# METRO COTABATO WATER DISTRICT

## SUPPLEMENTAL / BID BULLETIN

### ADDENDUM NO. 21-02

#### **“1 Lot – Proposed Design and Build of Modular Compact Water Treatment Facility and Equipment with a Capacity of 8MLD (PR#20-12-0755)”**

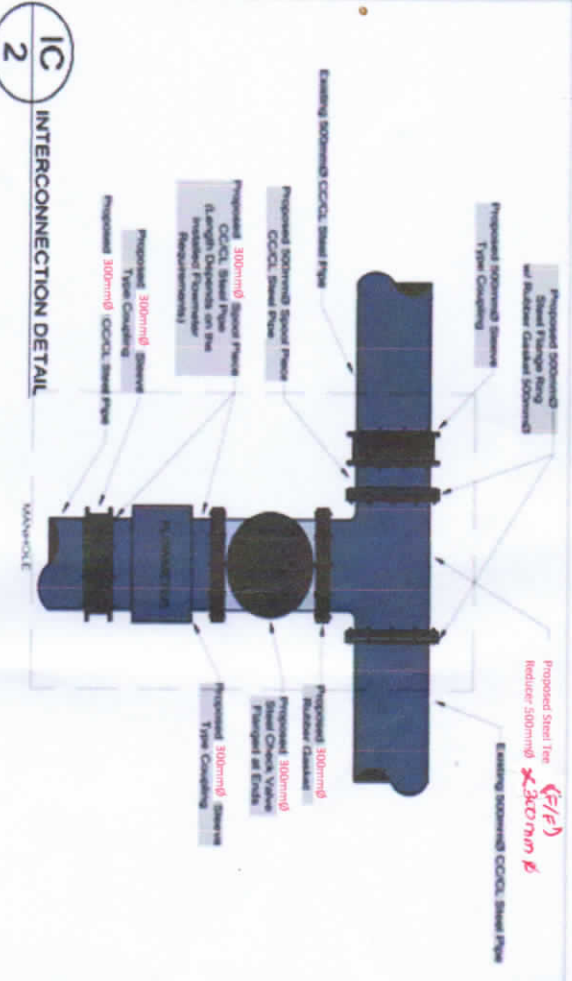
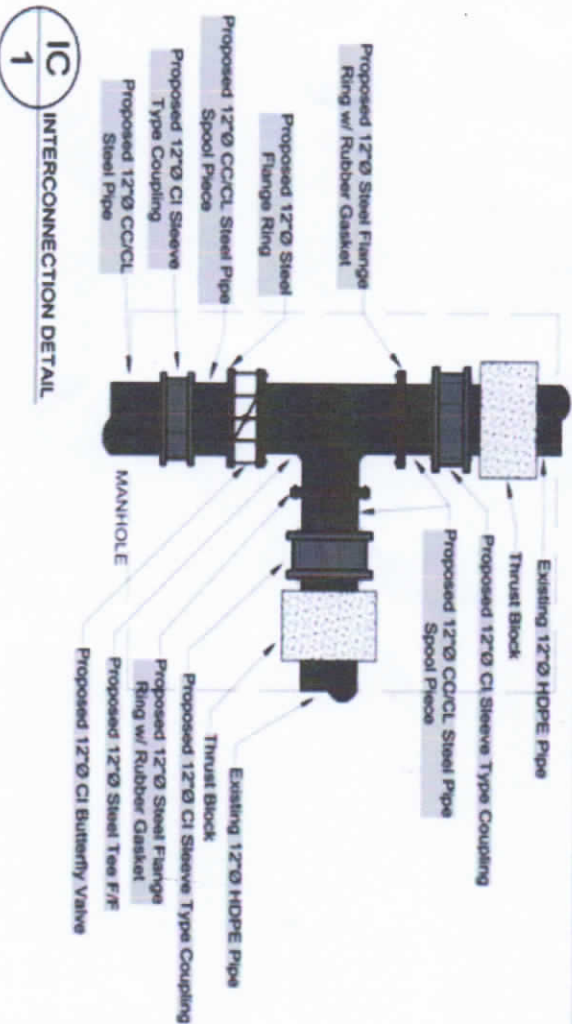
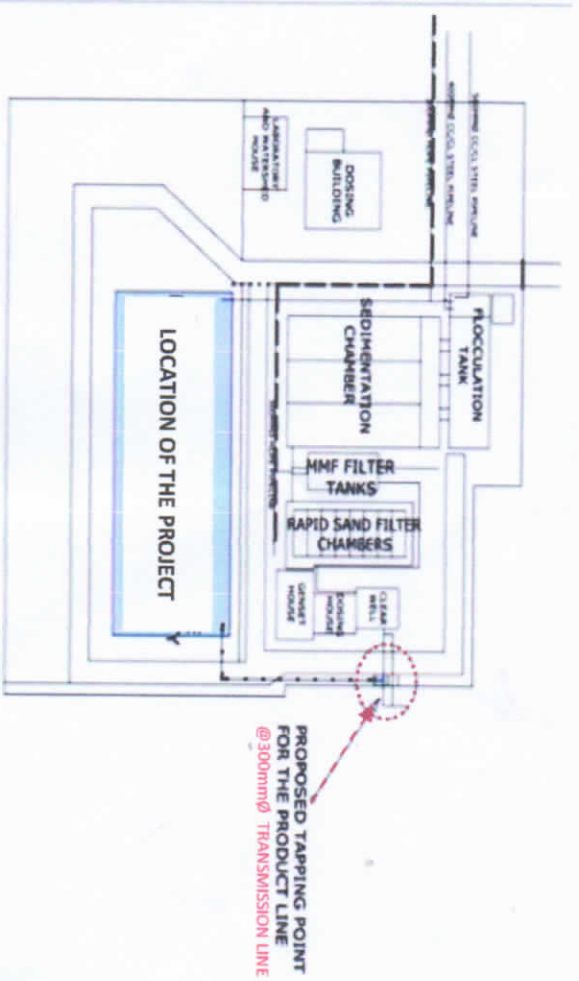
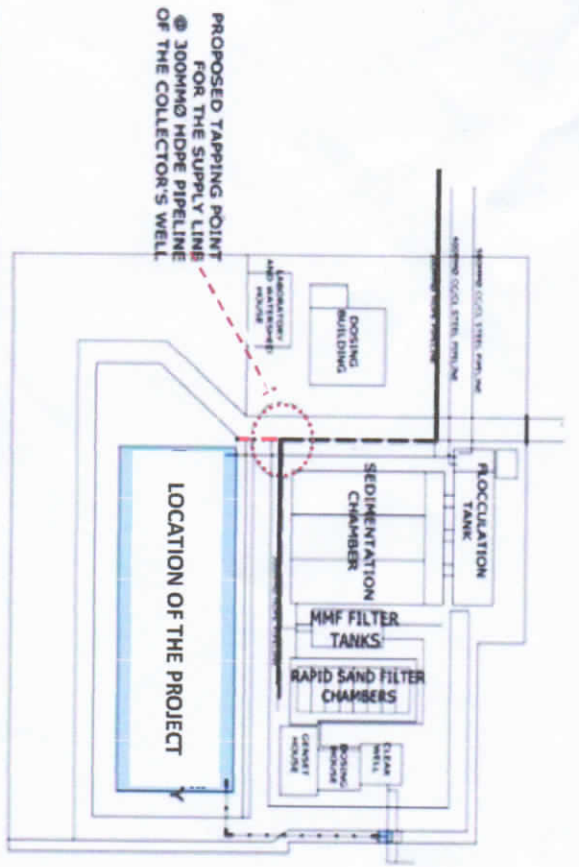
ORIGINAL	AMENDMENT
<p><b>Section VI. Specifications (page 89)</b></p> <p><b>6. PIPELINES, INTERCONNECTIONS, AND MANHOLES</b></p> <p><b>A. PIPELINES</b></p> <p>A.2.3. Pipe diameter must be at least 500mm (20”) Ø</p> <p>A.1.4. Thickness: 6.35mm for steel, Cement Coating (CC) -25mm, Cement Lining (CL) – 20mm</p> <p><b>Section VII. Drawings</b></p>	<p><b>Section VI. Specifications (page 89)</b></p> <p><b>6. PIPELINES, INTERCONNECTIONS, AND MANHOLES</b></p> <p><b>A. PIPELINES</b></p> <p>A.2.3. Pipe diameter must be at least 300mmØ (12”Ø)</p> <p>A.1.4. Thickness: 6.35mm for steel, Cement Coating (CC) -25mm, Cement Lining (CL)-(13mm)</p> <p><b>Section VII. Drawings</b></p> <p><b>Sheet #4 and Sheet #9 – See attached file.</b></p>
